PINS REFERENCE: EN020026

Written representation for Submission Reference [REDACTED]

- 1.1. This document comprises a Written Representation (**RRWR**) by myself (I/me) as an Interested Party in respect of a Development Consent Order **application** ("the DCO Application") for the National Grid ("NG") Sea Link project ("Sea Link").

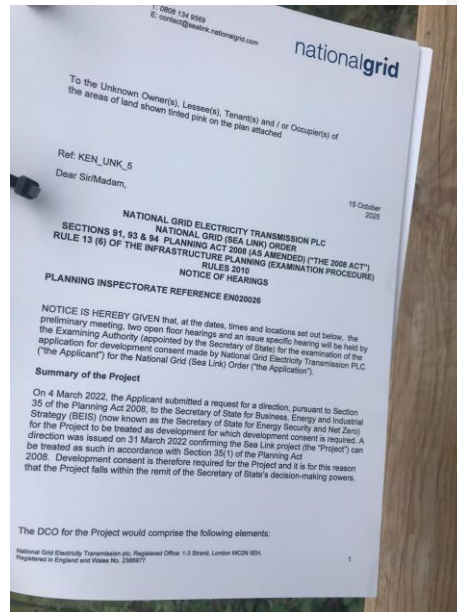
11.1. NG plan to take over 9 hectares of Best Most Versatile (BMV) land permanently out of production. It is not adequately described in the documentation nor is the fact that this is mostly Higher Level Stewardship land, which is not mentioned throughout the documentation. It is inconceivable that the Government should be paying farmers to manage their land with the environment in mind and then allow National Grid to remove it entirely. I refer back to the nascent NESO SESP

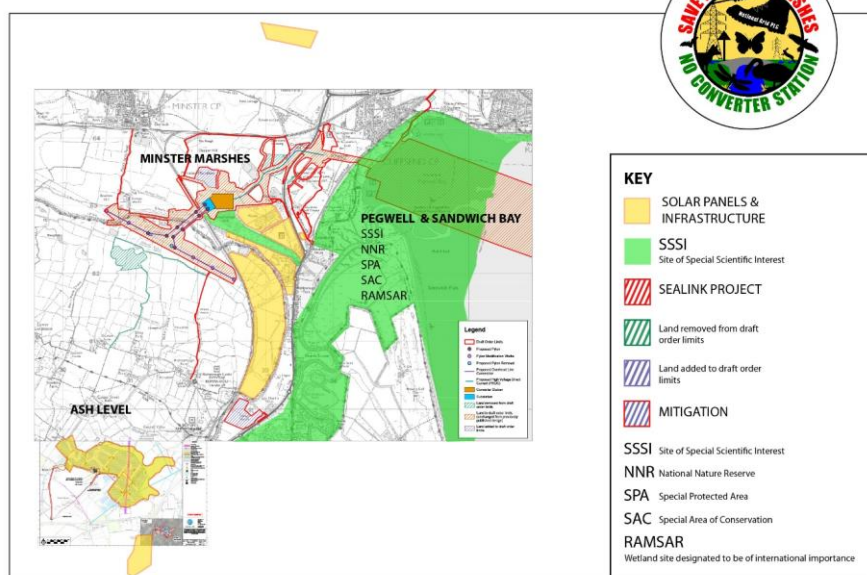
~~12.6:12.3.~~ The diagram, at 4.3 [Ibid] shows clearly that they did not hit bedrock chalk in their tests. It is simply the wrong location. Please please tell NG this is the wrong site and to review ~~SL1 as the best option: alternative sites suggested by KCC, Sir Roger Gale, MP, and others.~~
